Receive information and provide direction relative to the geotechnical analysis peer-review report for the Ocean Boulevard (Bluff) Erosion and Enhancement Phase 2 Project. (District 3)

**PEER REVIEW REPORT
OCEAN BOULEVARD EROSION AND ENHANCEMENT
PHASE 2 PROJECT
CITY OF LONG BEACH, CALIFORNIA**

**CITY OF LONG BEACH
Tidelands Capital Improvement Division**

June 23, 2014

Figure 1 - Design Cross-Section of Soil Nailing

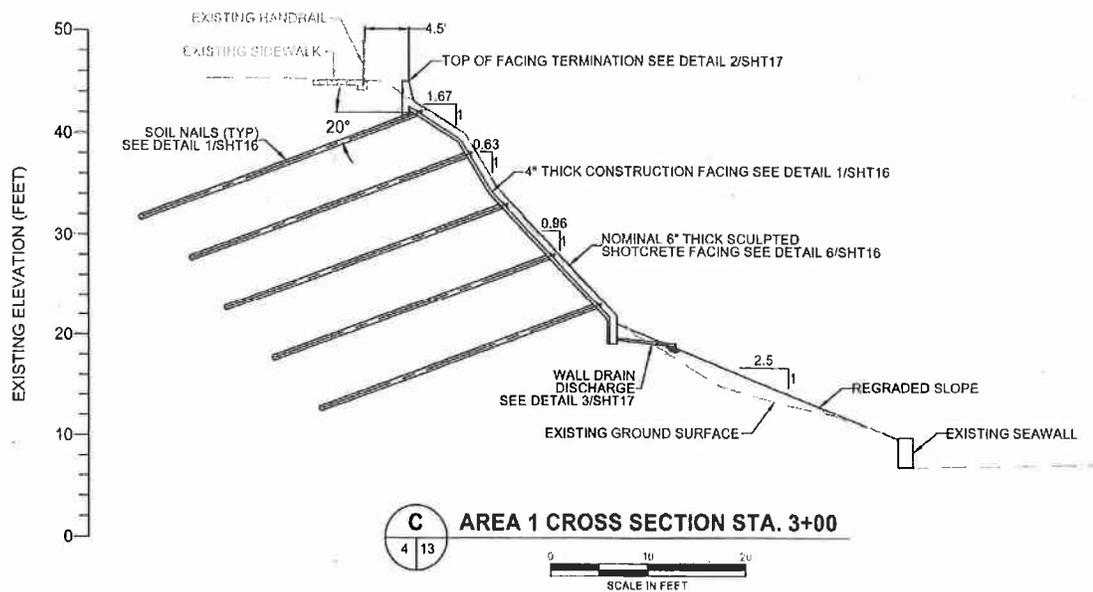
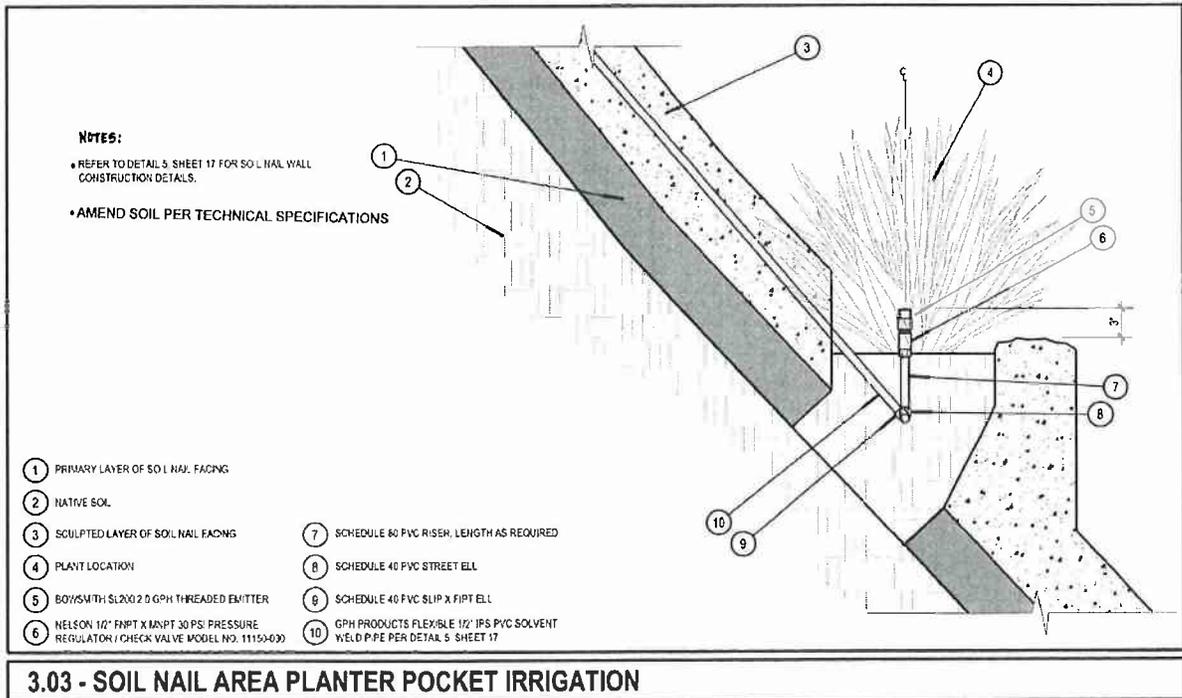
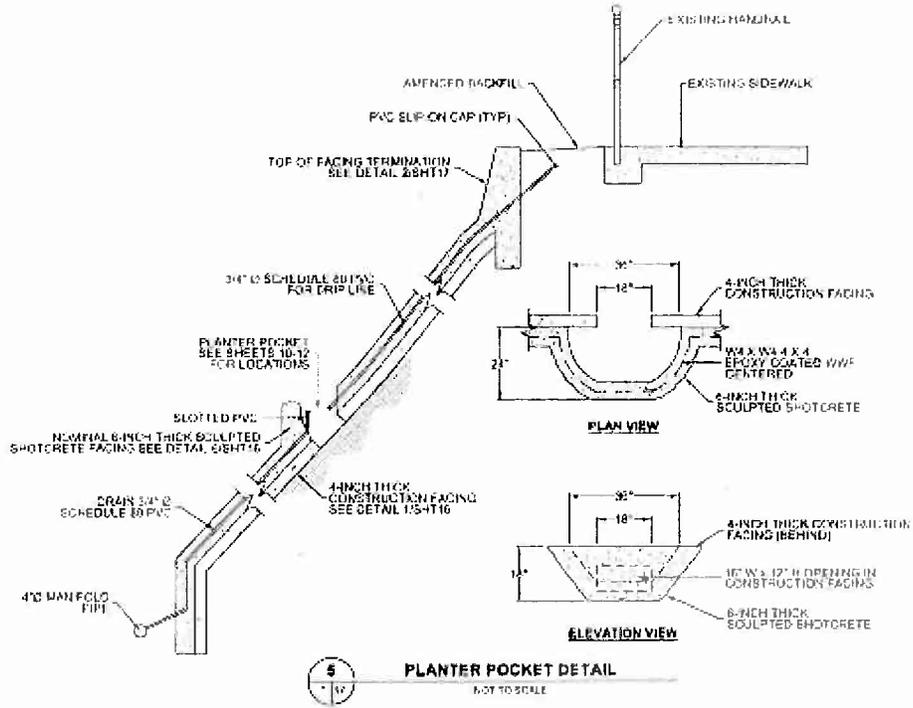
- Soil nails that enhance the deep-seated stability of the bluff under static and dynamic conditions (Figure 1) and locally support portions of the sidewalk; and
- A shotcrete facing (Figure 1) that protects the slope surface from weathering and erosion caused by surface water, and enhances the surficial stability.

It is the Committee's opinion that the recommendations on using soil nailing with shotcrete facing is reasonable considering the project parameters discussed in Section 2.1. An available alternative to shotcrete for slope face protection is using biotechnical techniques as discussed later in Section 3.0.

Figure 3 – Example of Deep-Rooted Vegetation

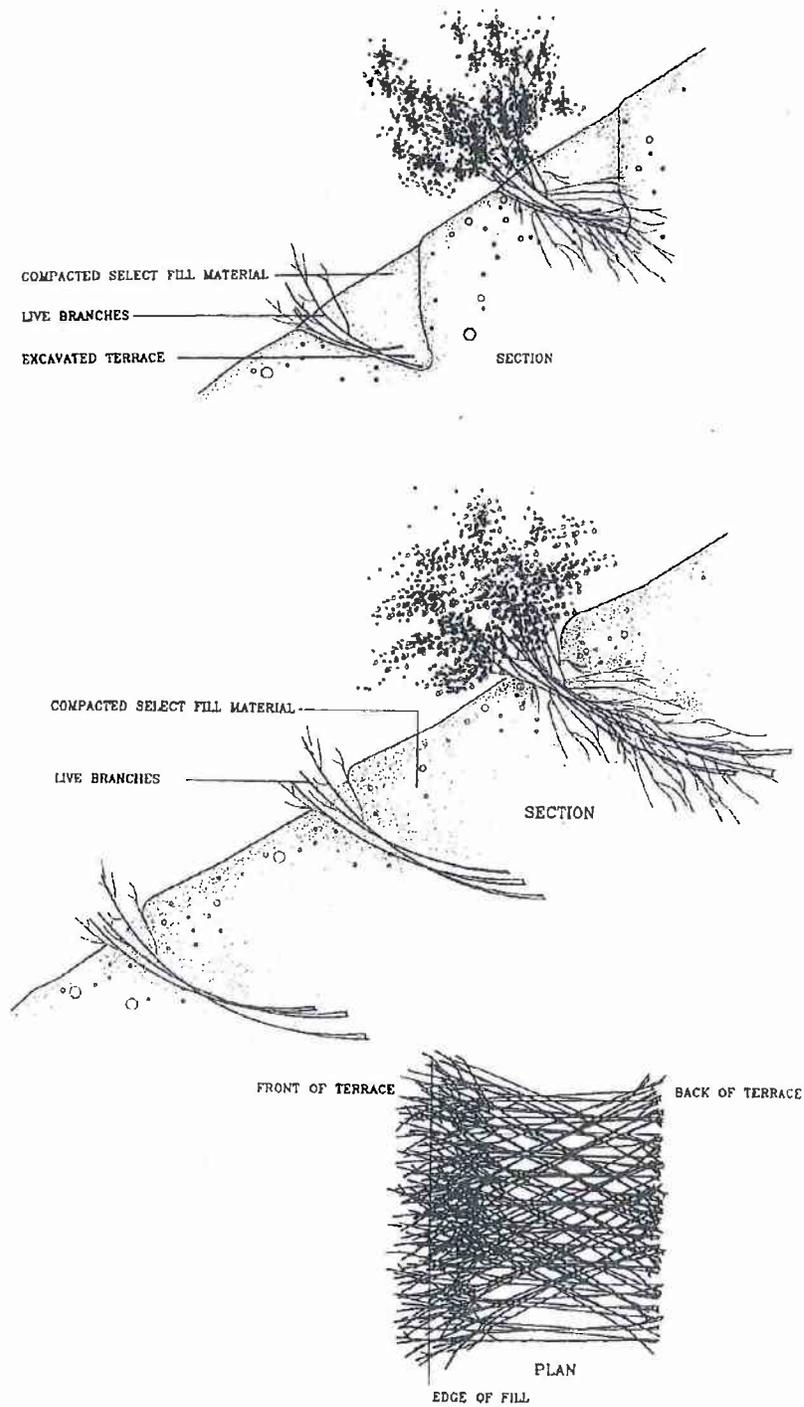
- Deep rooted vegetation as depicted in Figure 3;
- Deep rooted vegetation in combination with geogrid or timber grid used to hold topsoil and slope plantings as shown in Figure 4; and
- Live slope grating where a lattice-like array of vertical and horizontal timbers are fastened or anchored to a steep slope and the openings in the structure are filled with suitable backfill material and layers of live branch cuttings (see Figure 5).

These biotechnical techniques could be considered for the subject slope instead of shotcrete, especially for slope inclinations of 1:1 or flatter. Although biotechnical techniques generally provide excellent erosion protection, the resulting vegetation requires significant maintenance. Biotechnical techniques only improve the stability of the near-surface soils and provide a very limited benefit for deep-seated instabilities; thus, they are not a substitute to soil nails as their depth of influence is limited.
